## Official Recall Notification U.S. Federal Boat Safety Act

## Mercury Diesel 2.8L/4.2L Tier 2 Fuel Return Hose Replacement

Revised September 2016. This service bulletin supersedes the previous service bulletin number 2016-64/OEM 2016-64 May 2016.

61225

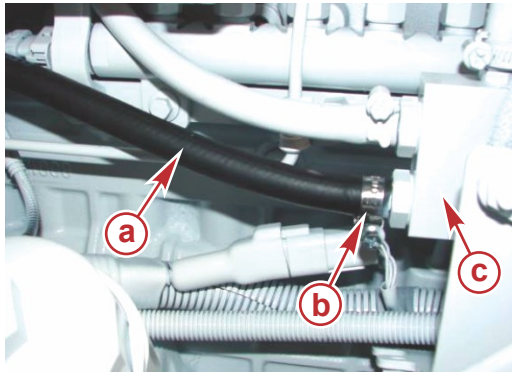
- Remove the hose clamp from the fuel return hose at the fuel distribution block.

- a** - Fuel return hose
- b** - Hose clamp
- c** - Fuel distribution block

61226

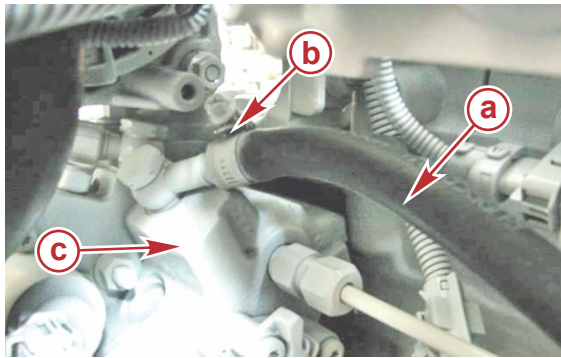
- Remove the hose from the fuel distribution block and drain any remaining fuel into the drain pan.
- Remove the hose clamp from the end of the fuel return hose near the fuel injection pump.

- a** - Fuel return hose
- b** - Hose clamp
- c** - Fuel injection pump

- Remove and discard the fuel return hose and hose clamps.
- Remove the drain pan from the engine compartment.

61129

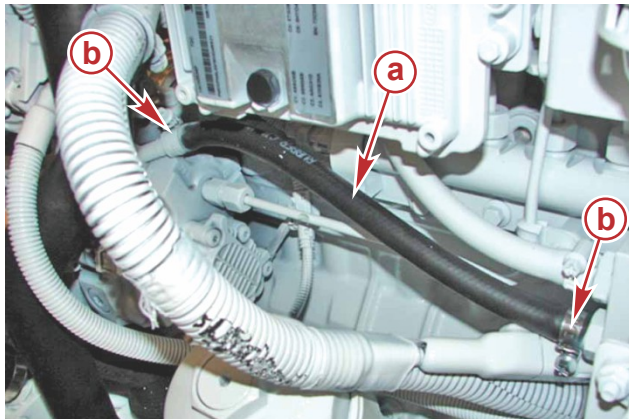
- Install the new fuel return hose between the fuel distribution block and fuel injection pump.

- a** - Fuel return hose
- b** - Hose clamps

2.8L Tier 2 models	115 mm (4.53 in.)
4.2L Tier 2 models	295 mm (11.61 in.)

- Secure the fuel return hose with new hose clamps. Tighten the hose clamps to the specified torque.

Description	Nm	lb-in.	lb-ft
Hose clamps	1.5	13.3	-
